Westinghouse
Electric Corporation

NSD-NRC-97-4547
DCP/NRC0709
Docket No.: STN-52-003

SUBJECT: REFERENCES AND CHANGES FOR SSAR CHAPTER 7

Chapter 7 Changes for SSAR Revision 11

7.2 = 1 sheet 12

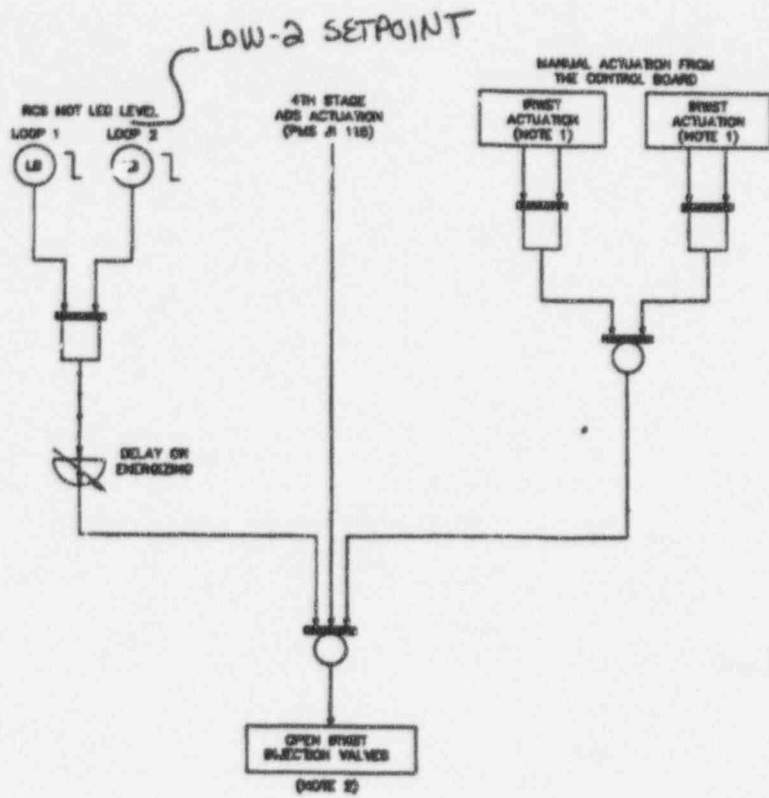
auxiliary spray and
A signal to isolate the letdown purification lines is generated upon the coincidence of pressurizer level below the Low-1 setpoint in any two of four divisions. This helps to maintain reactor coolant system inventory. This function can be manually blocked when the pressurizer water level is below the P-12 setpoint. This function is automatically unblocked when the pressurizer water level is above the P-12 setpoint. The functional logic relating to this is illustrated in Figure 7.2-1, sheet 12.

a. High-2 control room supply air radiation	2	1/2	None
b. Undervoltage to Class 1E battery chargers	2/charger	2/2 per charger and 2/4 chargers ³	None
17. <i>Auxiliary Spray and</i> Purification Line Isolation (Figure 7.2-1, Sheet 12)

SSAR Figure 7.2-1
sheet 16

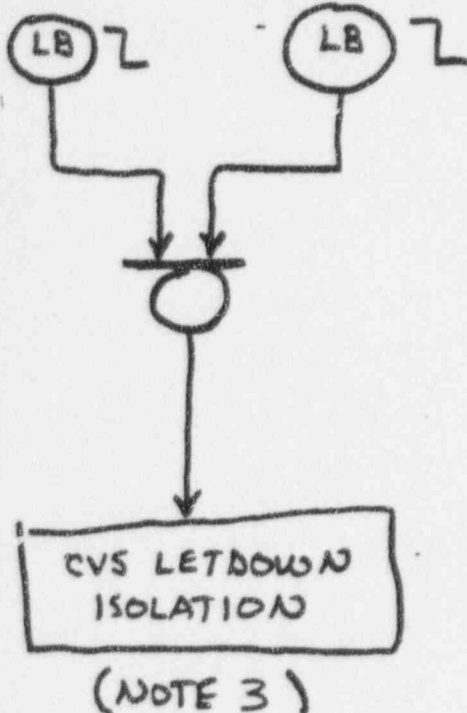
A signal to isolate the letdown valves of the chemical and volume control system is generated upon the occurrence of a low-1 hot leg level in either of the two hot leg loops. This helps to maintain reactor system inventory. The functional logic relating to this is illustrated in Figure 7.2-1, sheet 16. These letdown valves are also closed by the containment isolation function as described in subsection 7.3.1.2.1.

24. Chemical and Volume Control System Letdown Isolation (Figure 7.2-1, Sheet 16)

Figure 7.2-1 (Sheet 13 of 20)

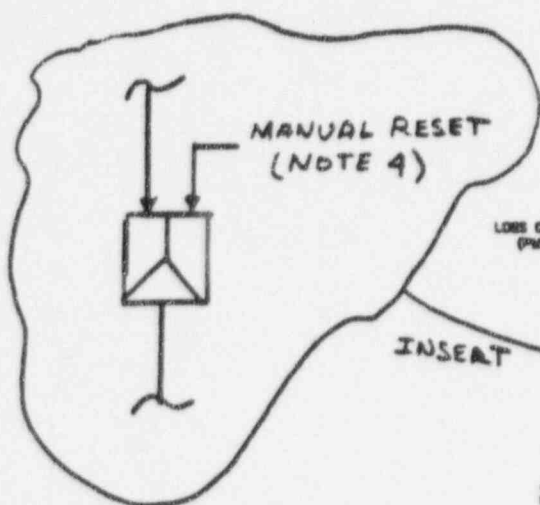
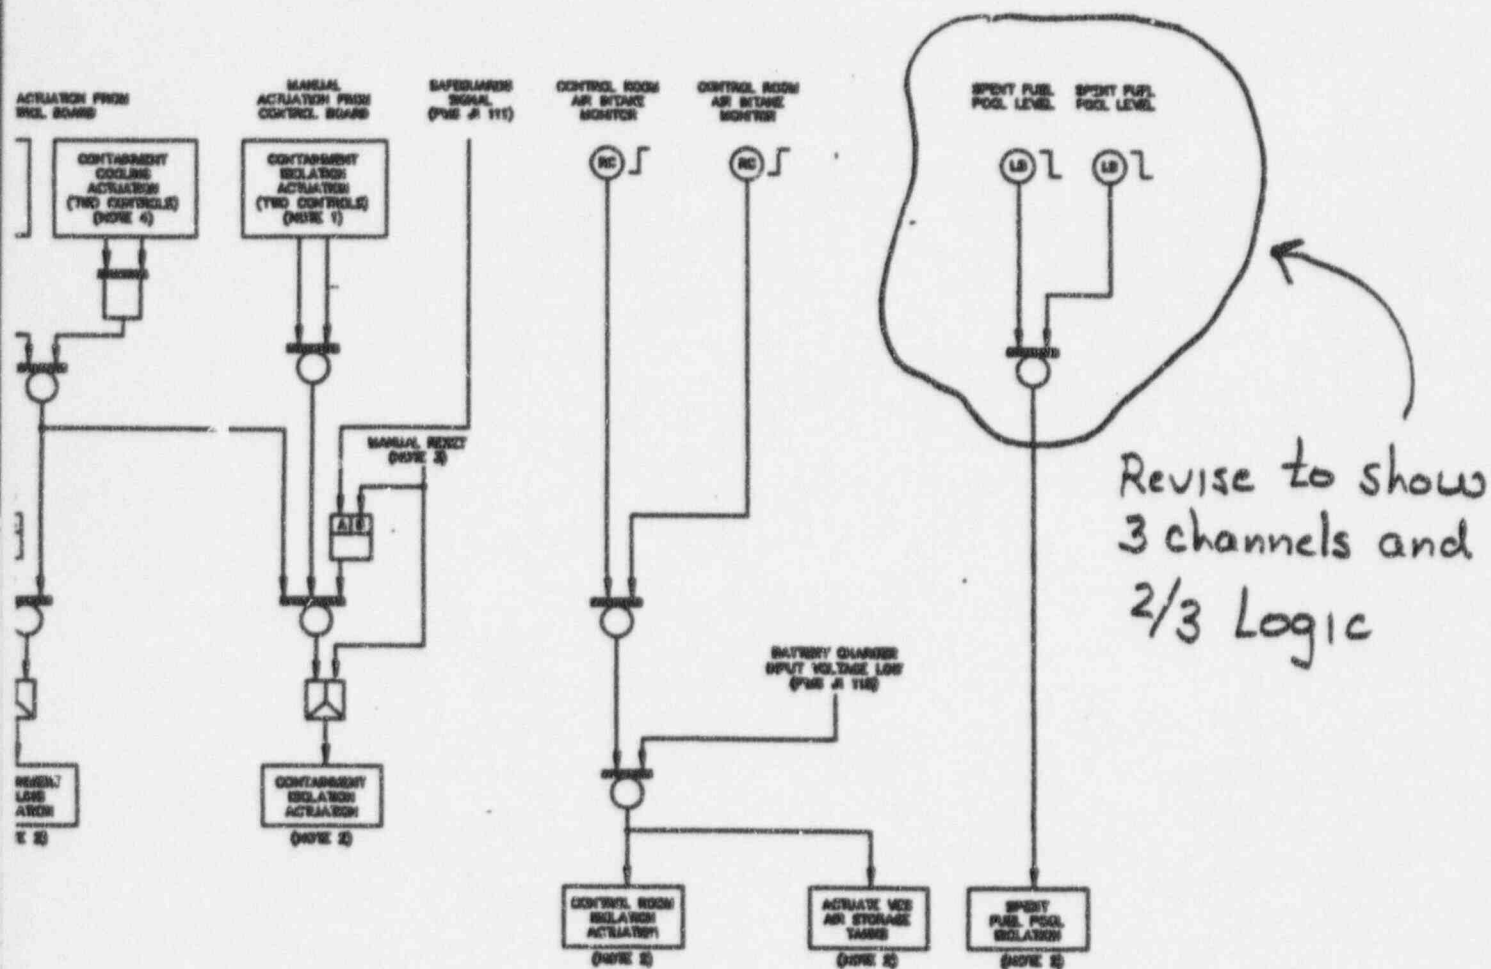
ADD TO NOTES

A signal for isolating the spent fuel pool lines is generated upon the coincidence of spent fuel pool level below the Low setpoint in ^{two} ~~any one of four~~ ^{three} divisions. This helps to maintain the water inventory in the spent fuel pool due to line leakage. The functional logic relating to this is illustrated in Figure 7.2-1, sheet 13.

20. Spent Fuel Pool Isolation (Figure 7.2-1, Sheet 13)			
a. Low spent fuel pool level	2 3	1/2 2/3	None
21. Open In-Containment Refueling Water Storage Tank (IRWST) Injection Line Valves (Figure 7.2-1, Sheet 16)
